R20TS0765EJ0100 Rev.1.00 Oct. 16, 2021

**RX** Family

Flash Module Using Firmware Integration Technology,

- 1. Notes on executing "R\_FLASH\_Write" on non-blocking mode
- 1. Notes on executing "R\_FLASH\_Write" on non-blocking mode

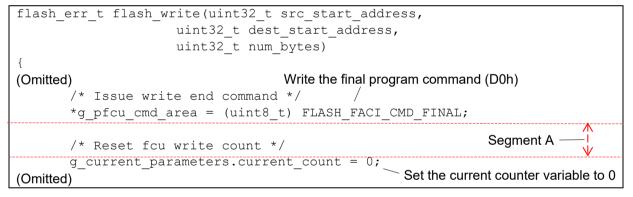
The code snippets show the segment of the main routine process, in which "flash\_write" of "r\_flash\_fcu.c" writes the final program command (D0h), and the current counter variable is set to 0.

If the time between the completion of D0h and the setting of the variable gets longer than the programming time for the flash memory, an FRDY interrupt request interrupts the variable setting.

If an interrupt request occurs during (2) when the one-cycle instruction is executed, and if the interrupt processing time gets longer than the programming time for the flash memory, an FRDY interrupt request occurs, and the current counter variable is not set to 0.

Refer to the following and change <code>r\_flash\_rx</code> <code>src</code> <code>r\_flash\_fcu.c</code> as shown in red.
